DATE: 06.12.2019
TO: ProTrak
FROM: Mitesh Baxi
Traffic Engineering

■ **OLEANDER COMMONS [TRC Plan Review]**

Initial Review Note

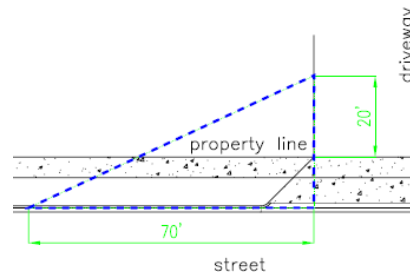
9. Revise and apply the City's 20'x70' sight distance triangle at each driveway as per below image on the site plan and landscaping plan. [Sec.18-529(c) (3) CofW LDC] [Sec. 18-812 CofW LDC]. Add a note indicating that all proposed vegetation within sight triangles shall not interfere with clear visual sight lines from 30"-10'. [Sec.18-556 CofW LDC]
